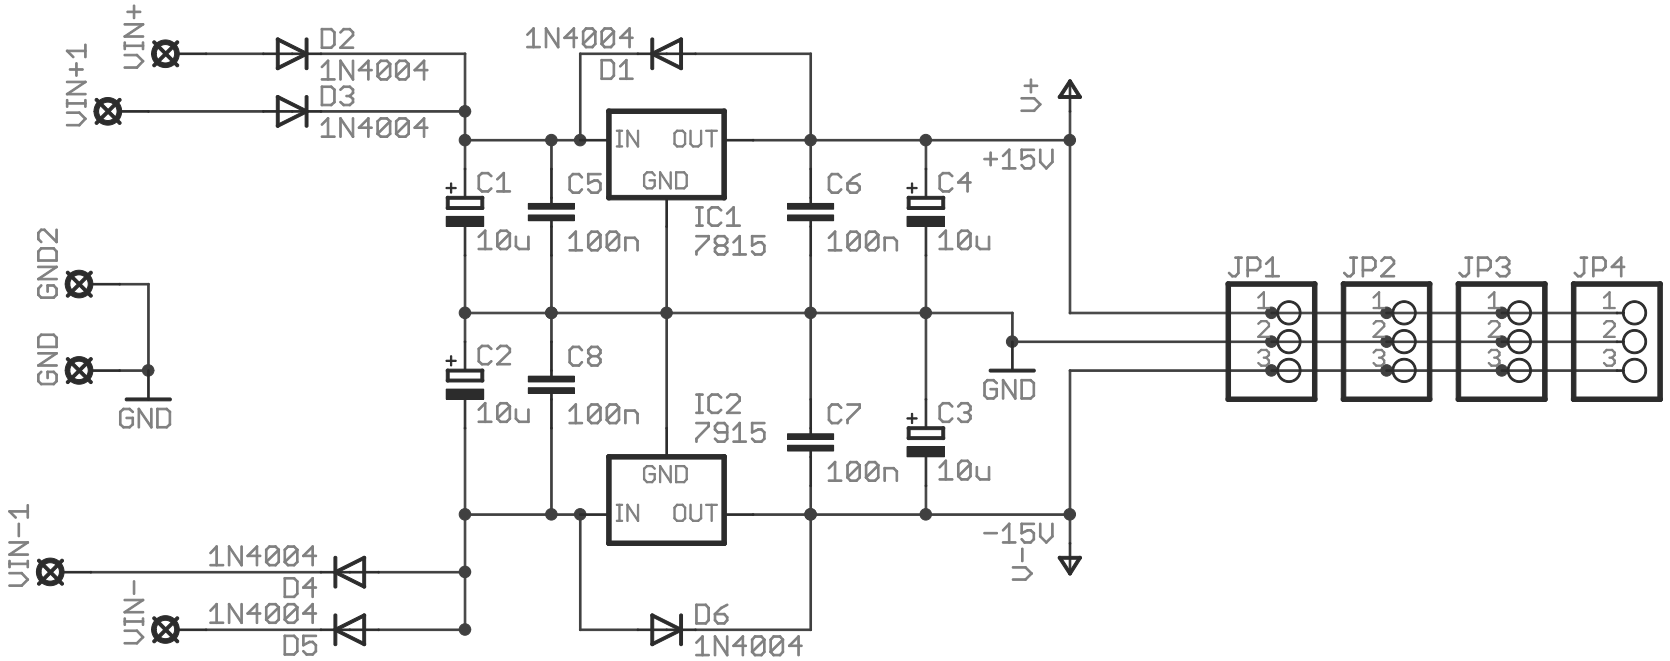
IC1 and IC2 should be screwed to case
using case as heatsink
don't forget isolation for 79xx
